# 1515 EARL ARMSTRONG PLAZA

**CONTRACT NO. 137404**

SHEET TITLE  
GENERAL PLAN

SHEET NUMBER  
001

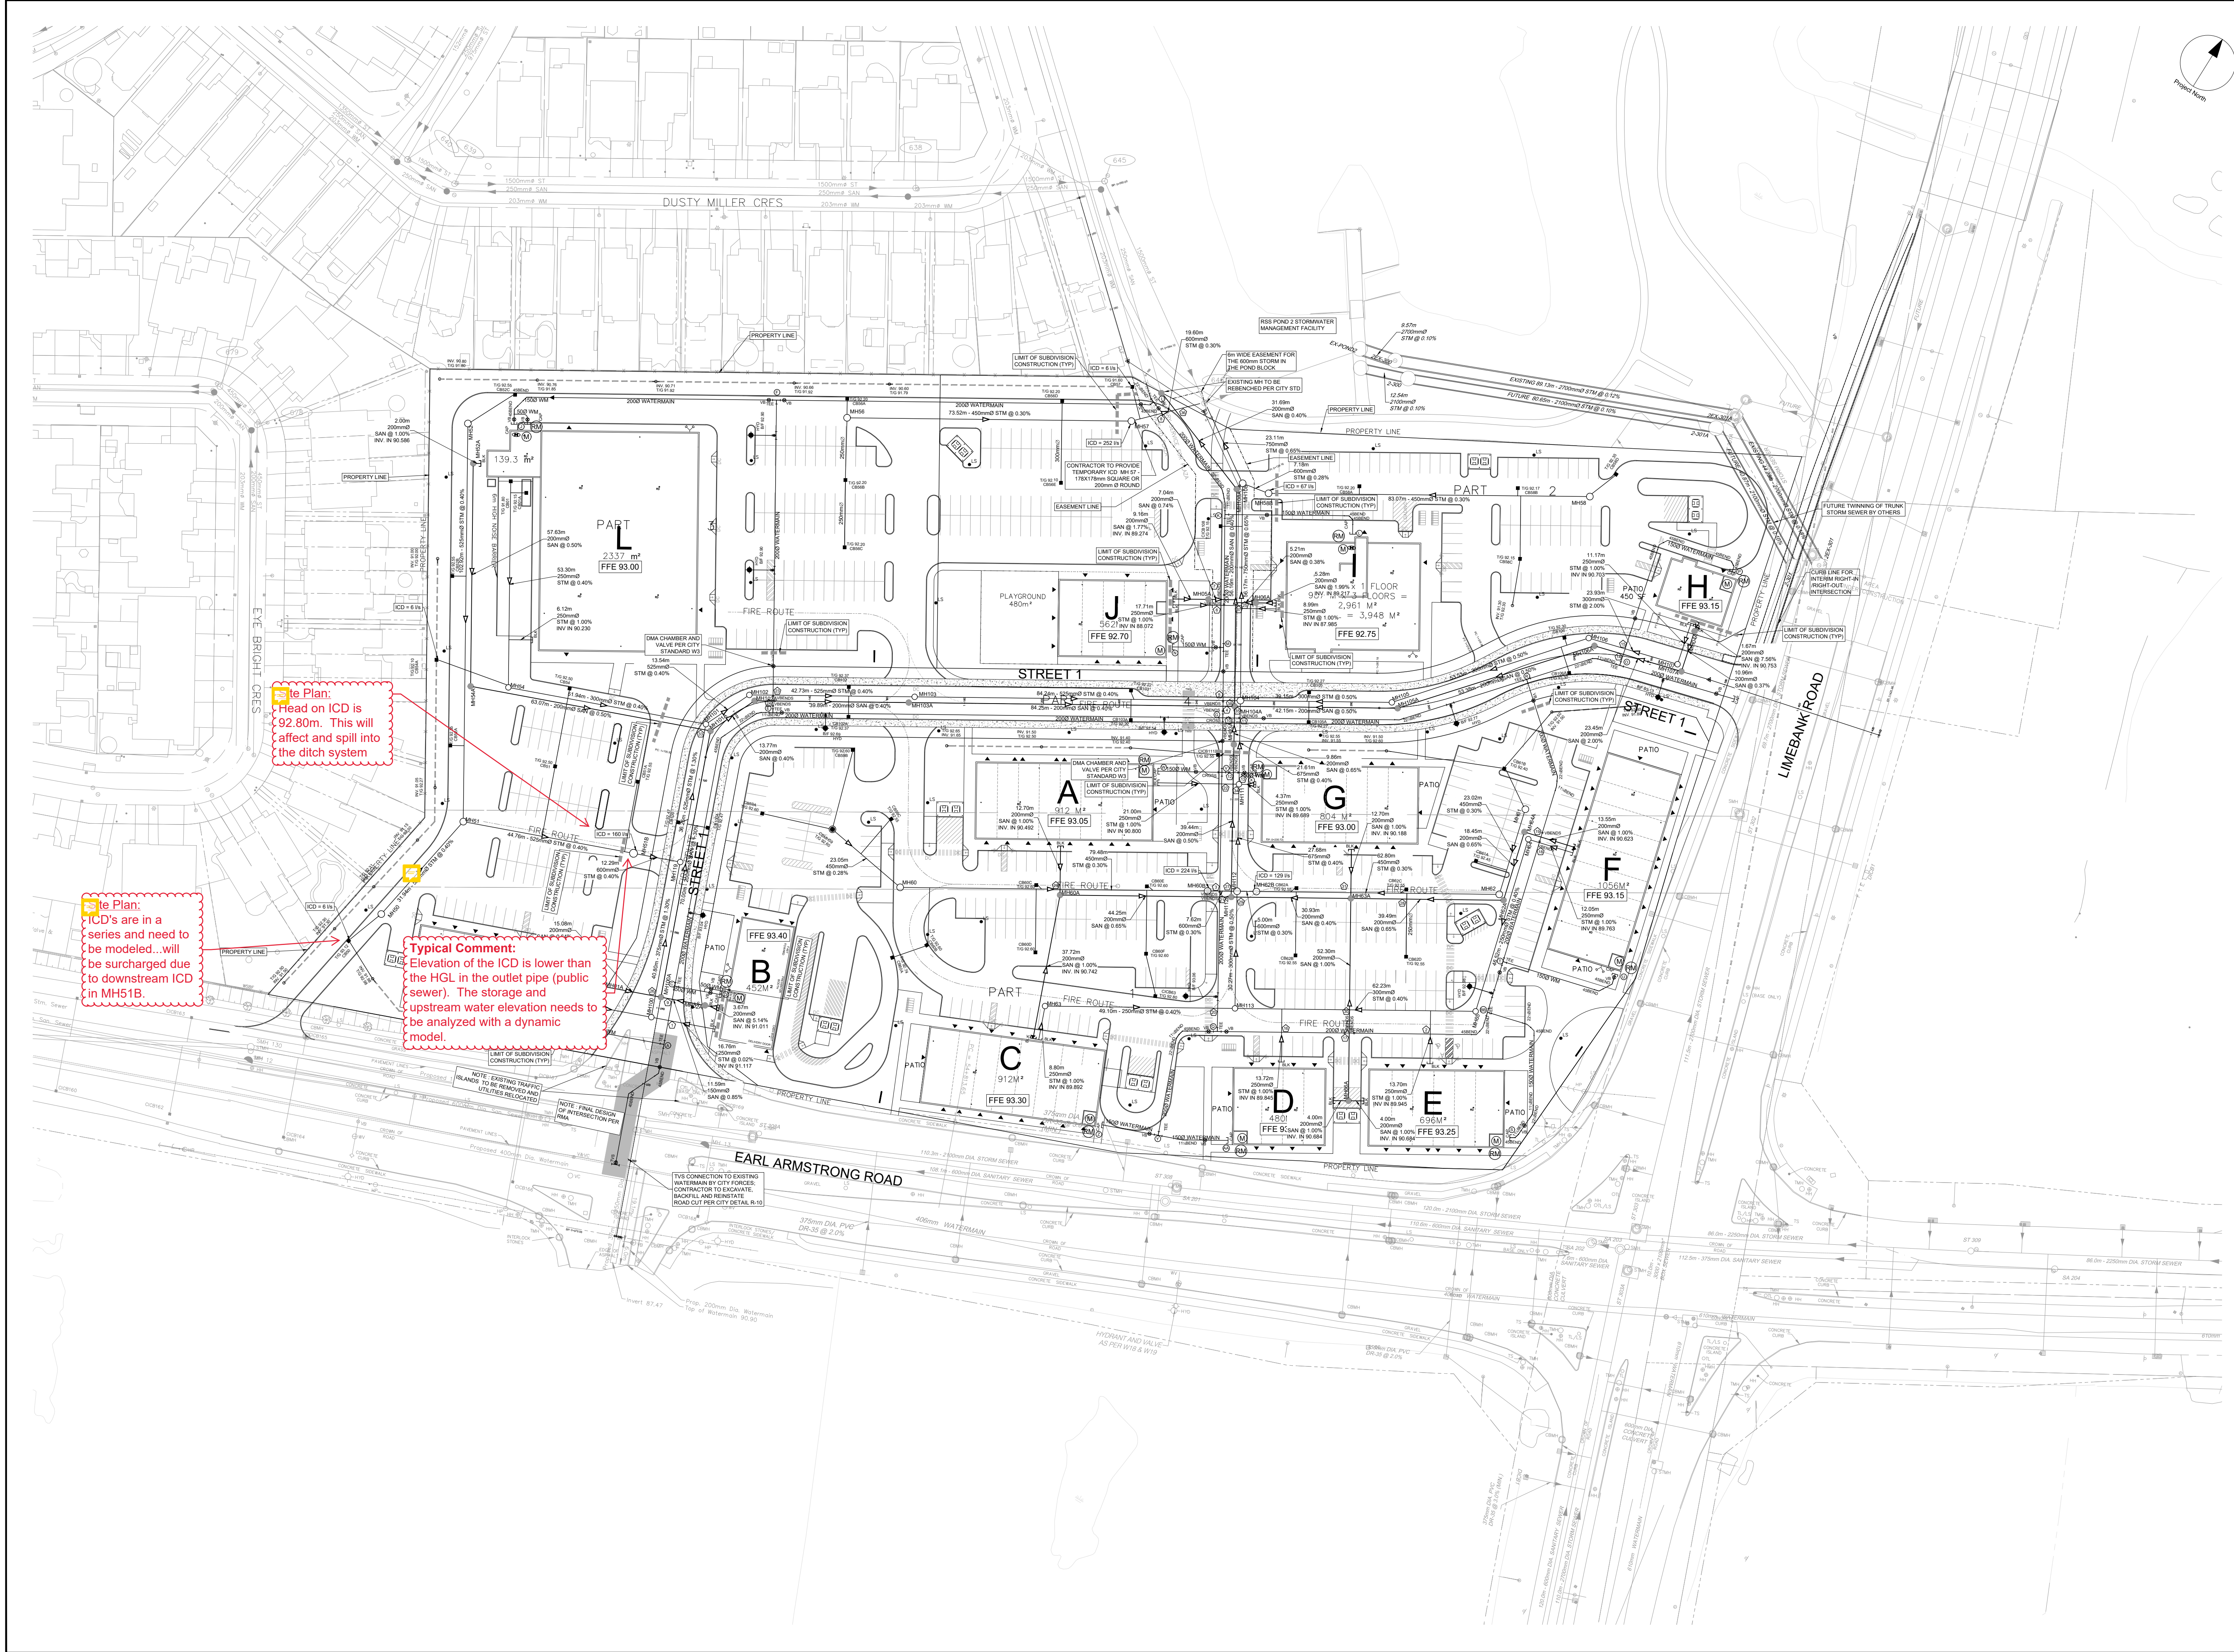
Site Plan:  
Head on ICD is 92.80m. This will affect and spill into the ditch system

Site Plan:  
ICD's are in a series and need to be modeled... will be surcharged due to downstream ICD in MH51B.

Typical Comment:  
Elevation of the ICD is lower than the HGL in the outlet pipe (public sewer). The storage and upstream water elevation needs to be analyzed with a dynamic model.

SHEET NUMBER 010 ISSUE 1

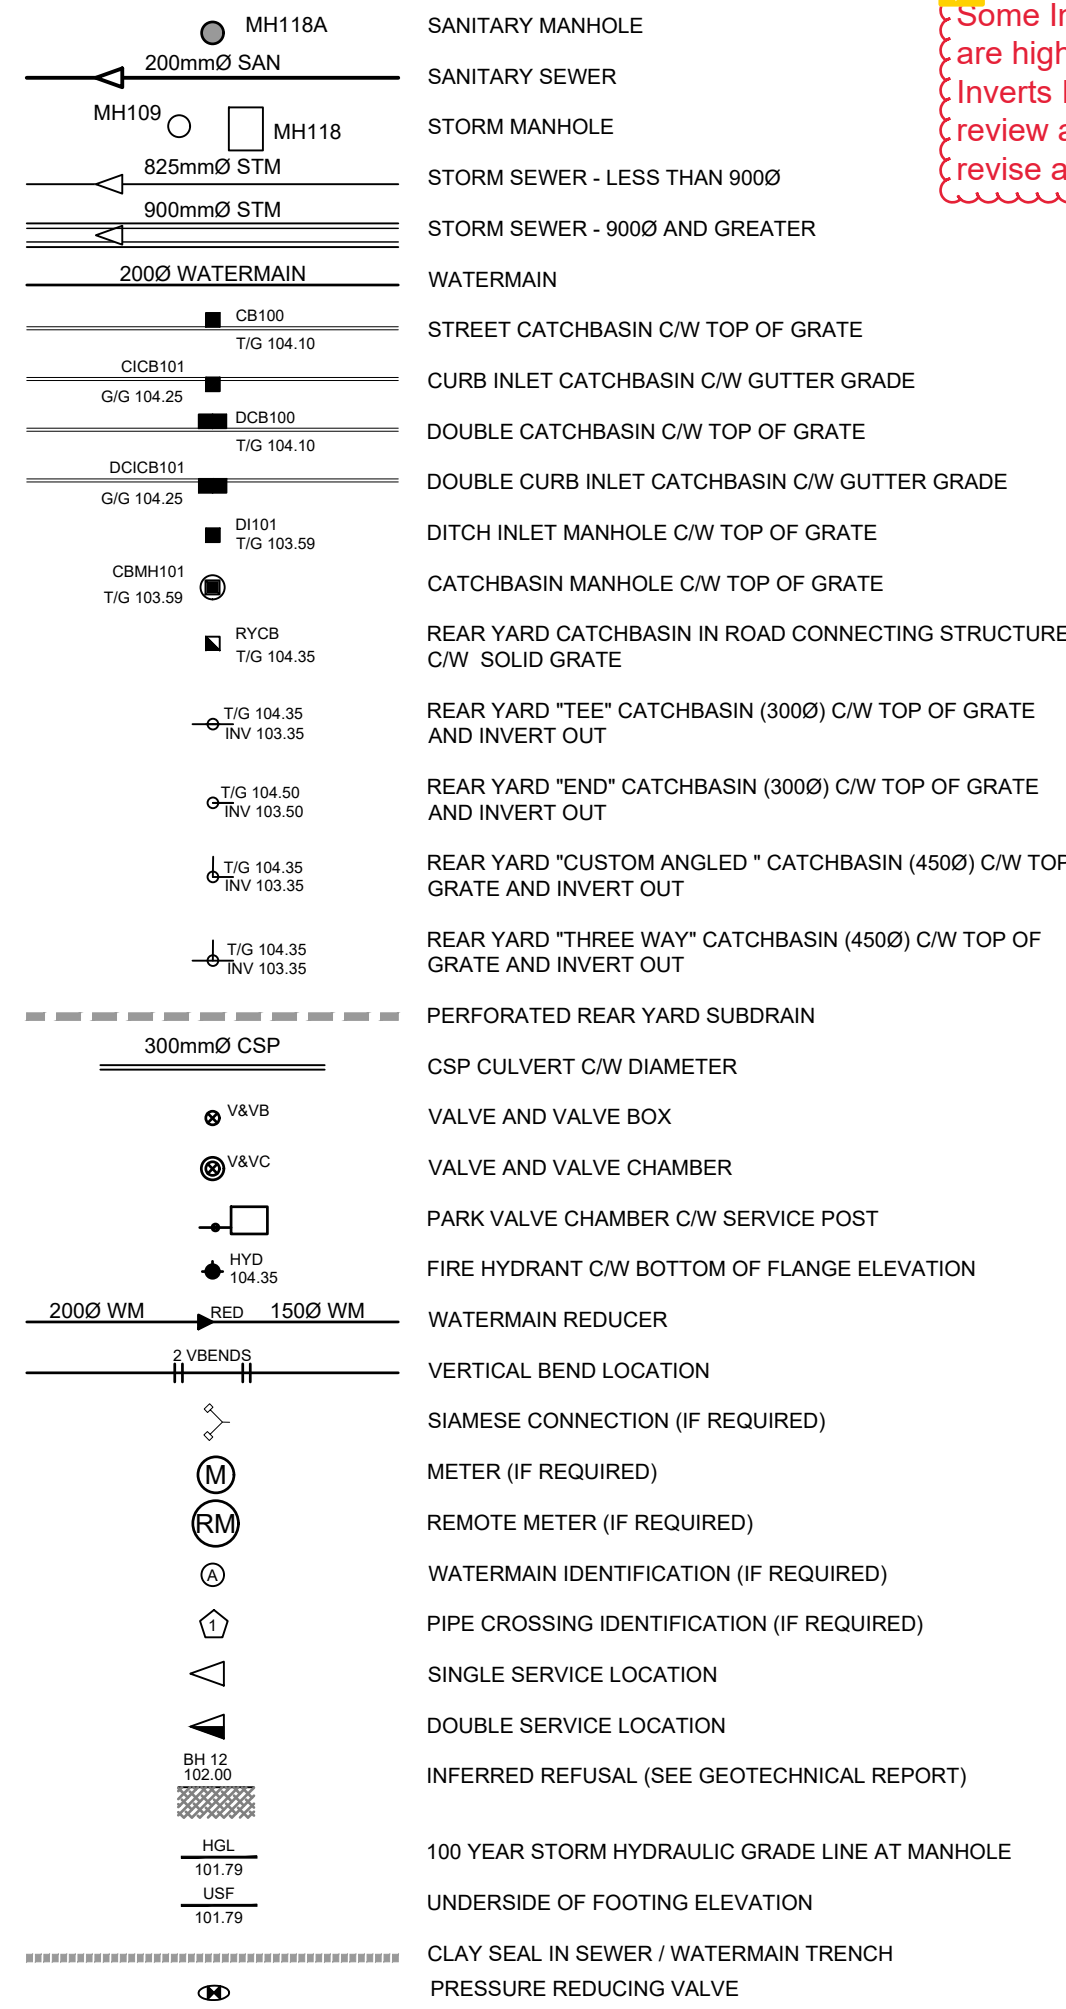
Typical Comment: Some Inverts Out are higher than Inverts In. Please review all and revise accordingly.
